**Town of Surfside
PLANNING & ZONING BOARD
AGENDA**

AUGUST 26, 2021 – 6:00 p.m.

To: Planning and Zoning Board
Thru: Andrew Hyatt, Town Manager
From: Walter Keller, PE, AICP., Town Consultant Planner
Marlin Engineering, Inc.
CC: Jason Greene, Assistant Town Manager
Lillian Arango, Town Attorney
James McGuinness, Town Building Official
Date: August 16, 2021
RE: 9173 Abbott Avenue – Front Yard Pool

To: Planning and Zoning Board
Thru: Andrew Hyatt, Town Manager
From: Walter Keller, PE, AICP., Town Consultant Planner
Marlin Engineering, Inc.
CC: Jason Greene, Assistant Town Manager
Lillian Arango, Town Attorney
James McGuinness, Town Building Official
Date: August 16, 2021
RE: 9524 Carlyle Avenue – Garage Conversion, Window Upgrades and new Deck

PROPERTY ADDRESS: 9173 ABBOTT AVE., SURSIDE, FL. 33154

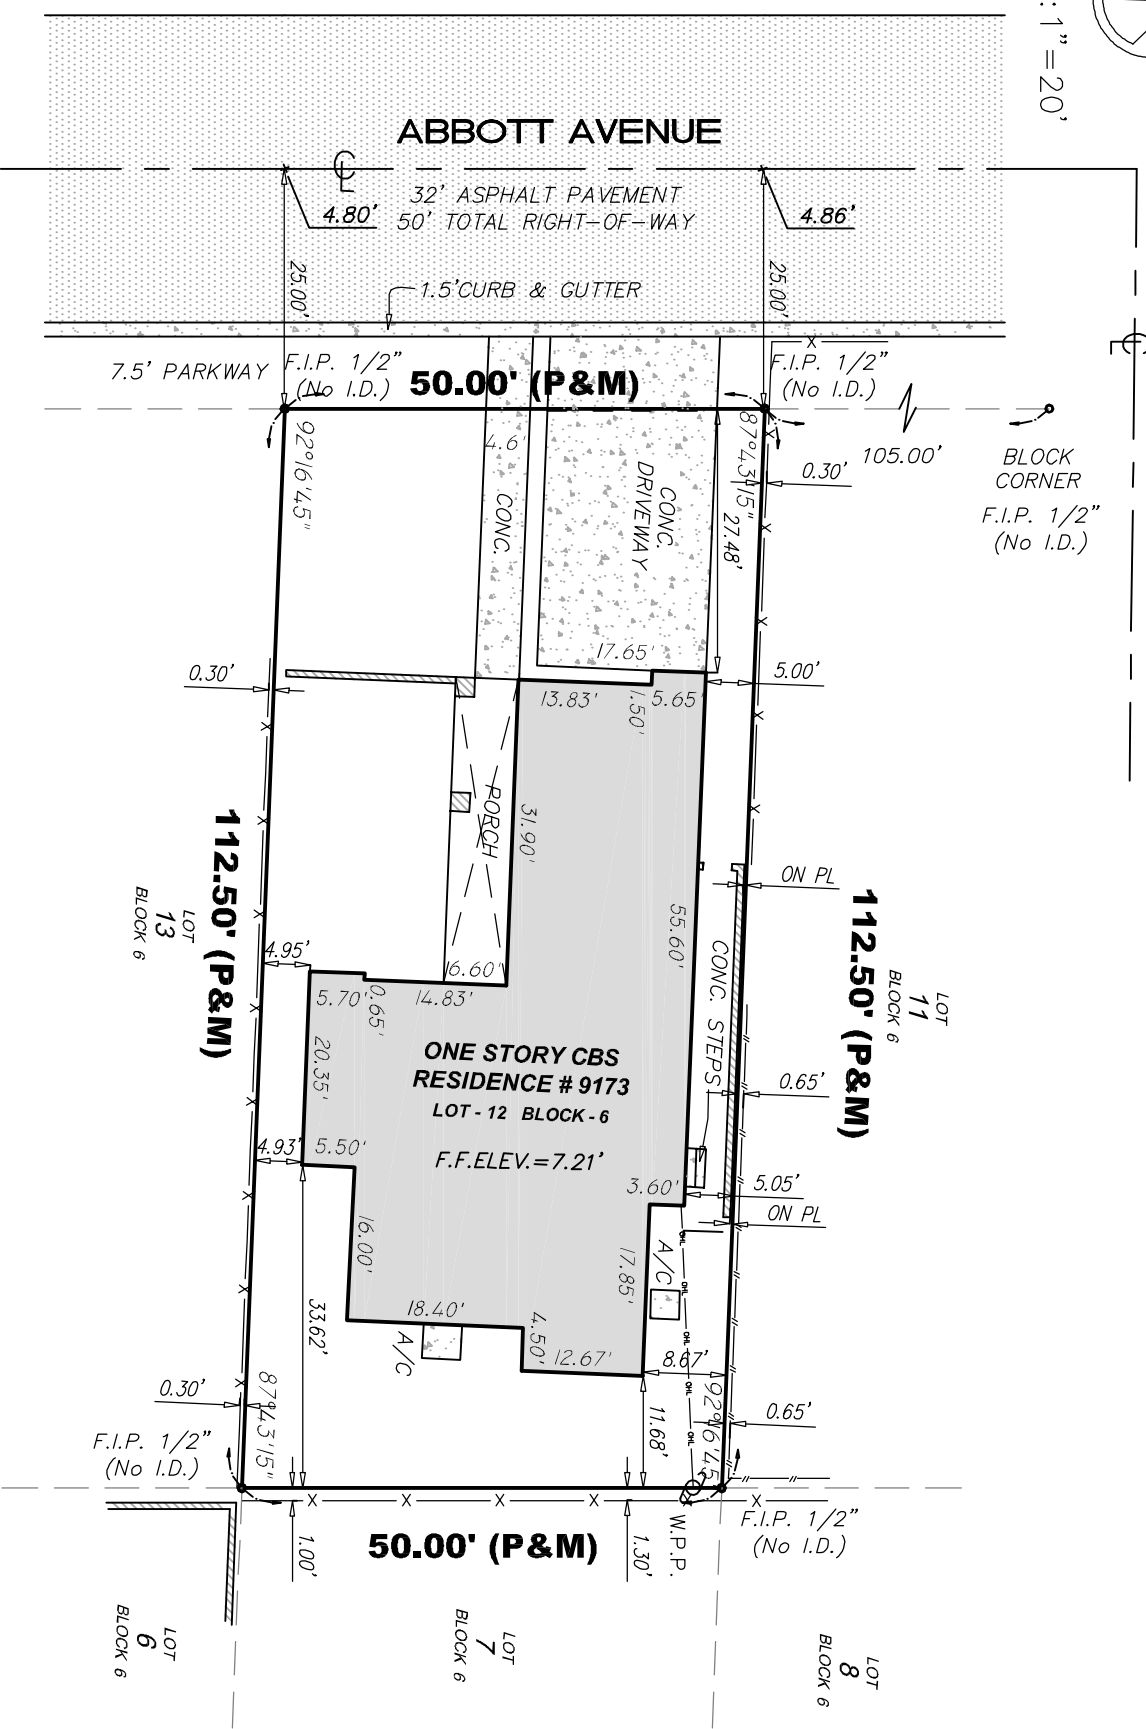
The pool plan does not include any deck or coping. The addition of these will reduce the landscape/pervious area total in the 20 foot front yard setback area where 50% landscape/pervious area is required. It appears the Applicant can meet the landscape/pervious area requirement but calculations and worksheets are needed.

The proposed 2-foot high front yard wall and landscaping hedges provide a viable option to walls and fences in the front yard provided the Planning and Zoning Board gives design approval.

- Provide additional dimensions on the site plan defining the location of the pool, pool coping and any deck with dimensions from the property line and other features.
- The wall separating the landscaping hedges and the pool needs to be approved by the Planning and Zoning Board.
- Include the proposed Den on the site plan with a note indicating "to be constructed."
- Provide calculations and worksheets verifying the 20-foot front yard setback area complies with the 50% landscape/pervious area requirement.

SITE DATA	
1.- PROJECT	HOME INTERIOR REMODELING
2.- PROPERTY ADDRESS	9524 CARLYLE AVE., SURFSIDE, FL 33154
3.- ZONING (MIAMI-DADE)	SINGLE FAMILY HOME
4.- NET LOT AREA	5,600 SQ. FT. (0.12 ACRES)
SITE COMPUTATION

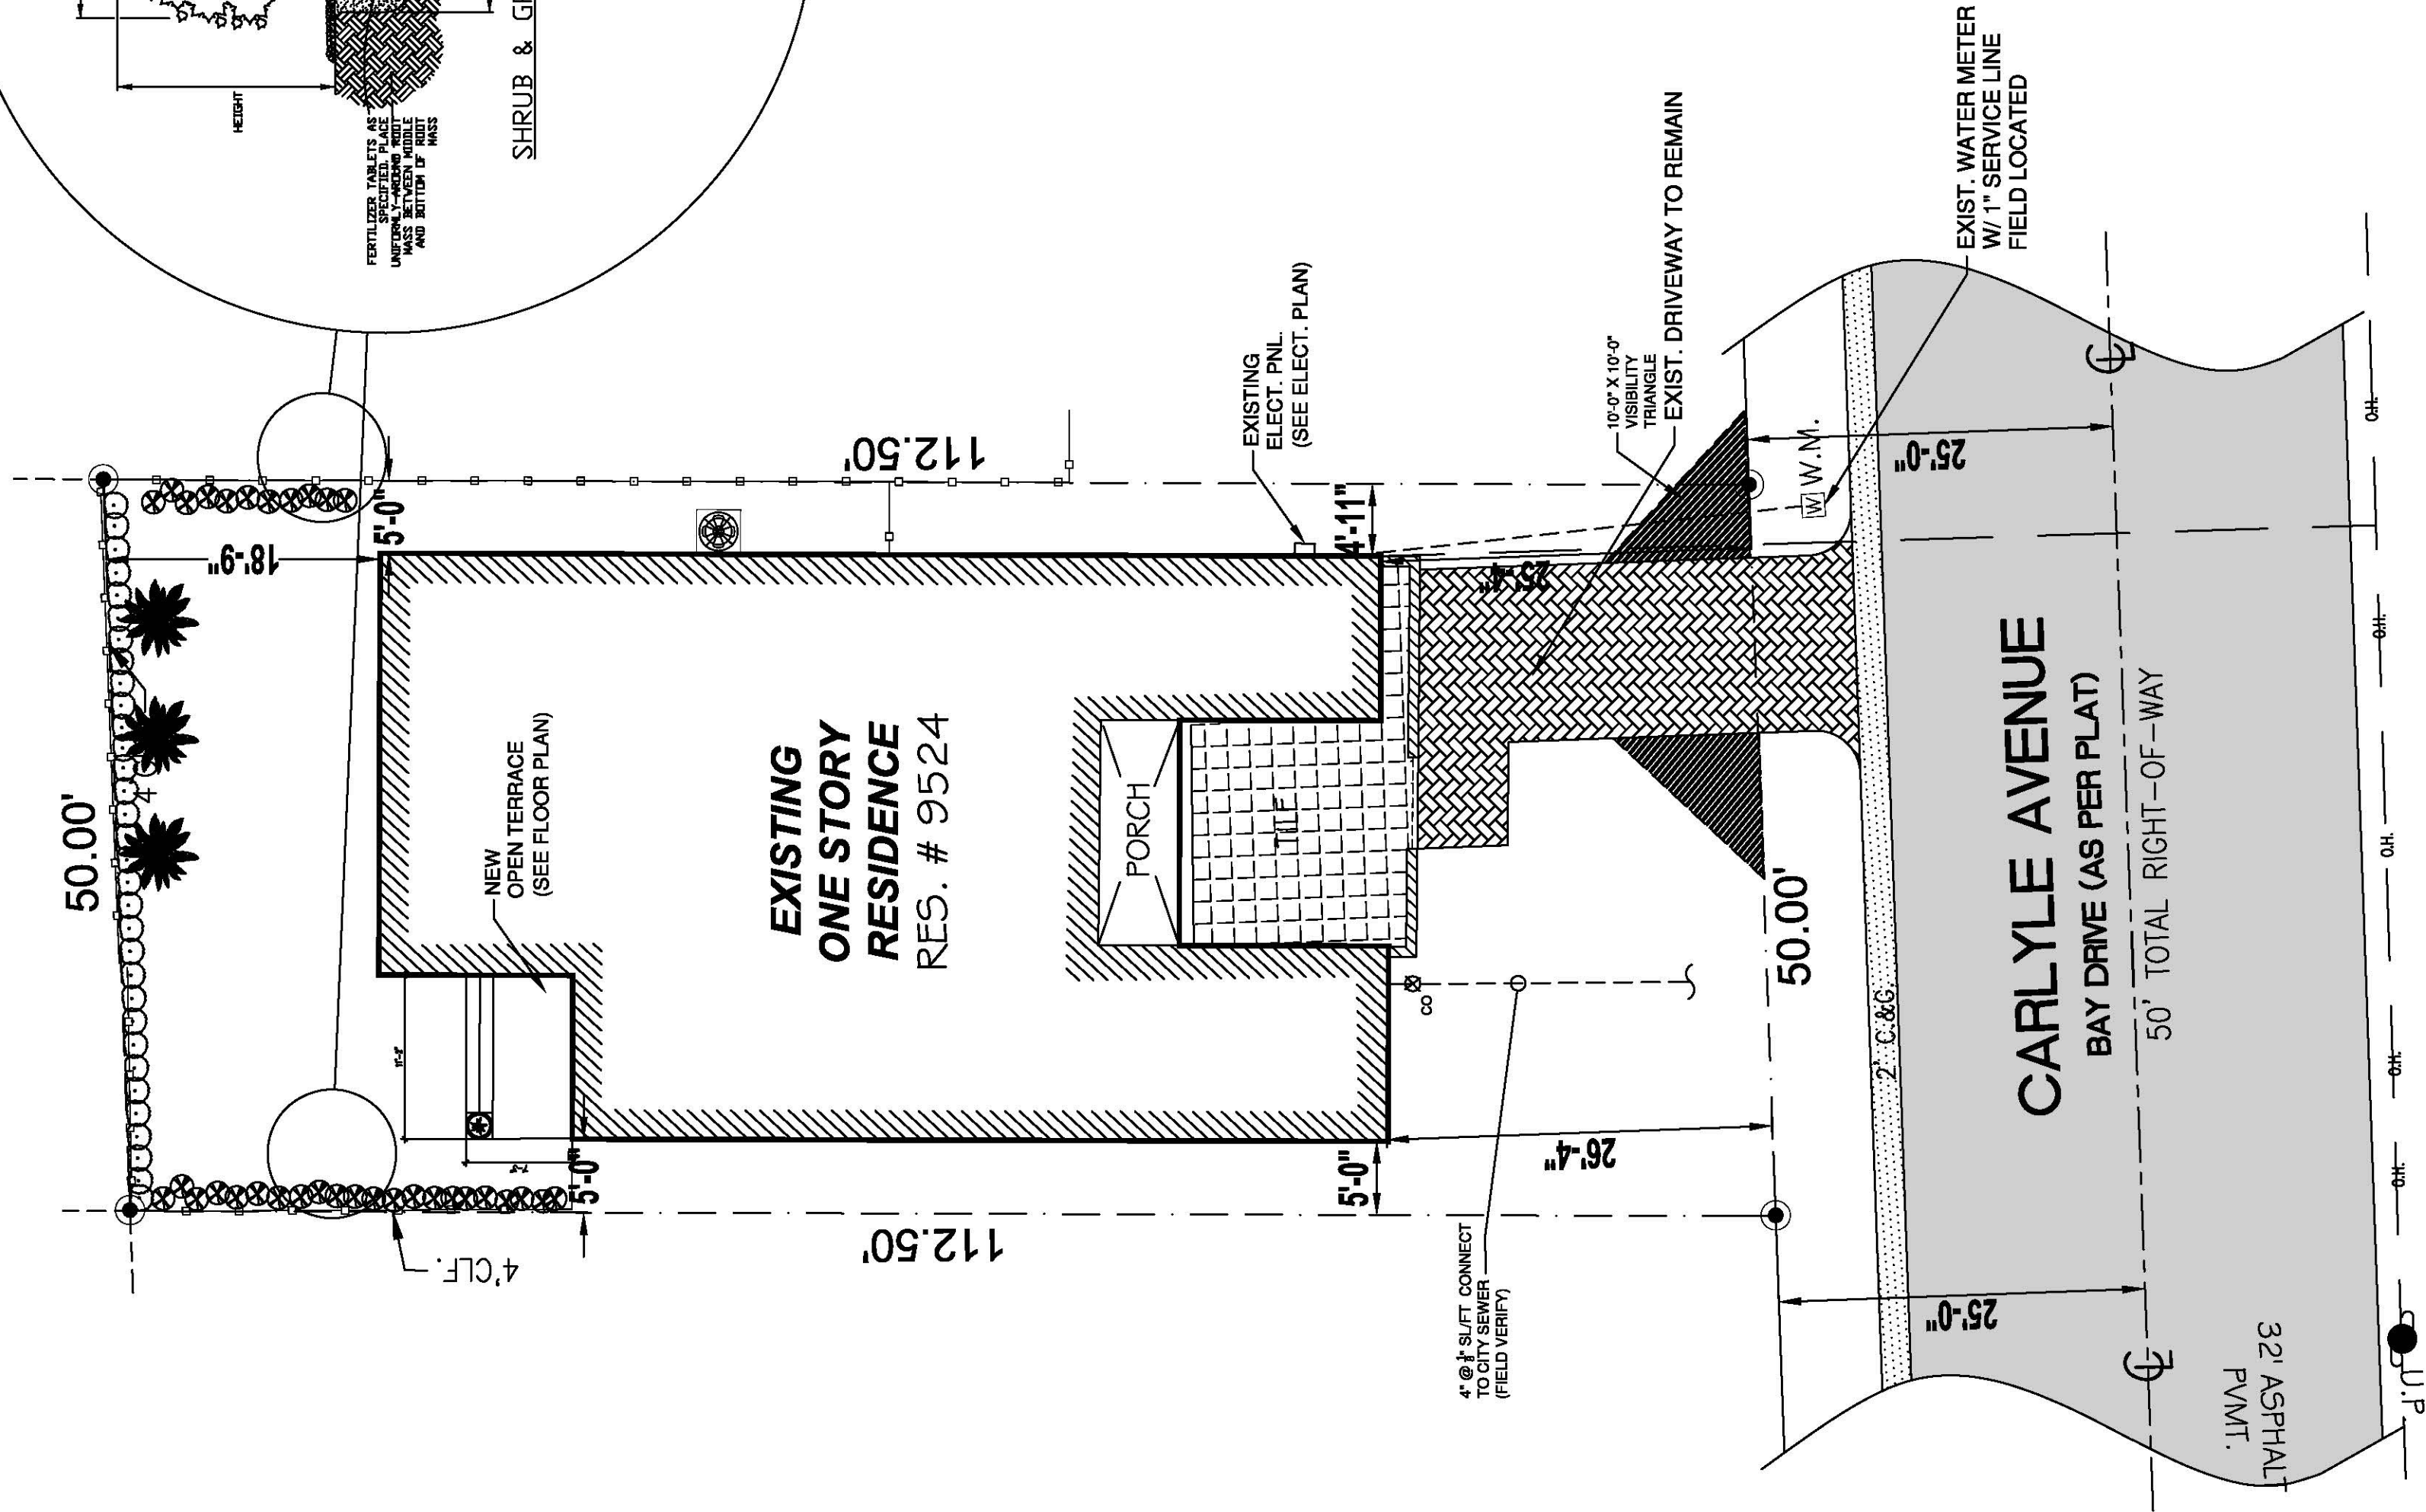
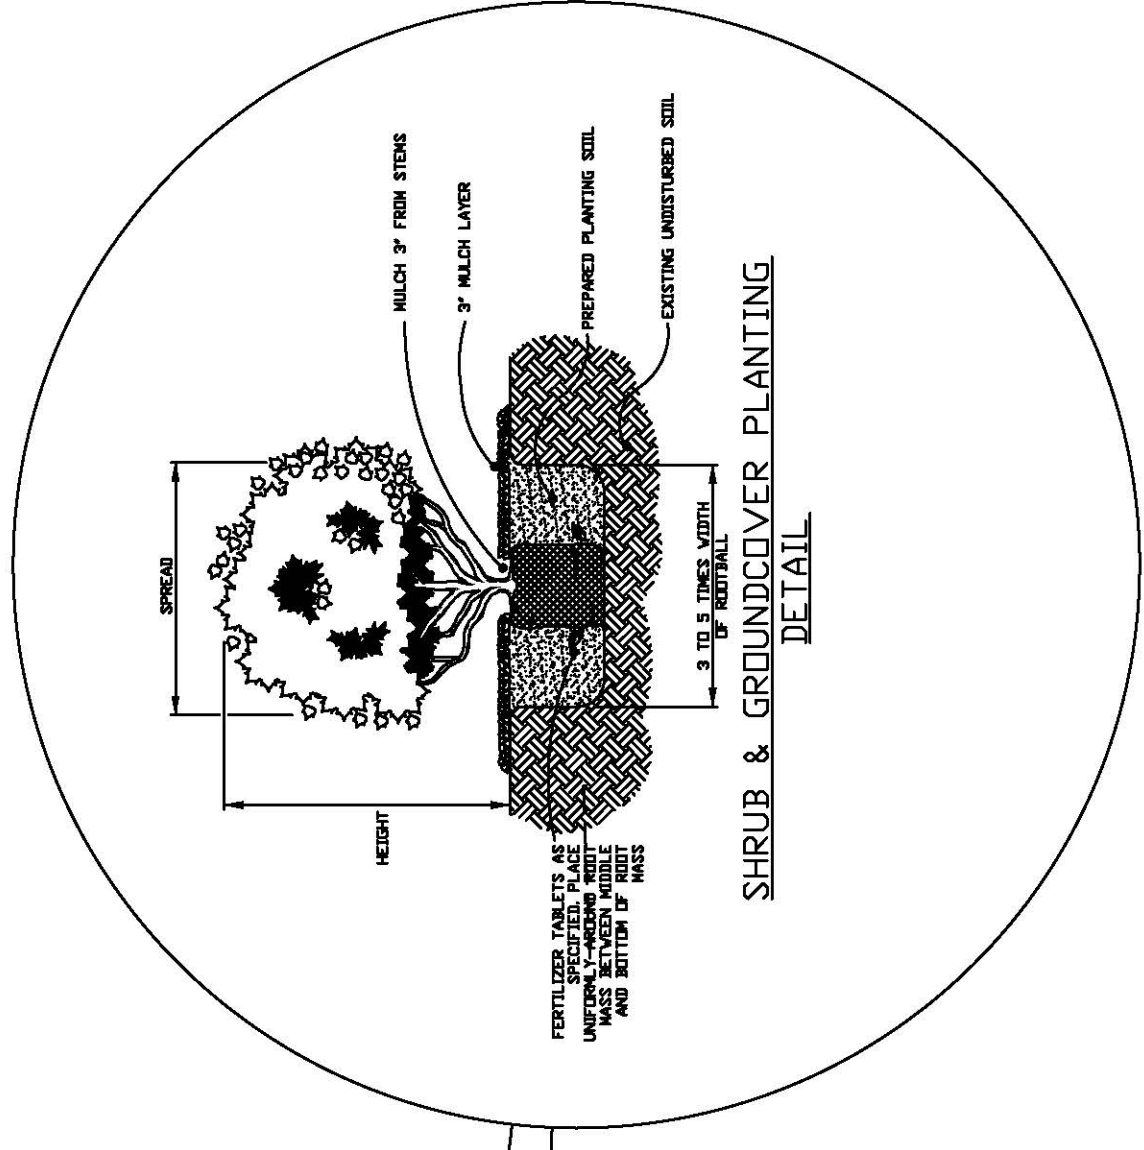
A Miami-Dade County Property Appraiser’s Angled photo is provided on the following page and a Google Street View photo is presented on page 3. The residence has a decorative block wall covering the front of the residence beginning at the north wall of the front bedroom, extending to the west wall of the garage. The Google Street View photo does not depict the windows in the existing east elevation and it is unclear how access to the existing garage is provided. The existing driveway does not appear as wide as that depicted in the site plan.

- Provide a clean copy of a recent property survey.
- The rear setback should be 20 feet where 18 feet 9 inches is provided.
- The floor of the existing garage should be raised to meet the existing floor elevation of the residence. Add a note that the garage floor will be raised to match the existing FFE of the residence.

- The driveway needs to be 18 feet in width to provide for 2 parking spaces with closure of the garage. Asphalt driveways are not allowed for new construction. Reconstruction of the driveway to provide the 18 foot width should be either pavers, stamped concrete or color texture treated concrete.
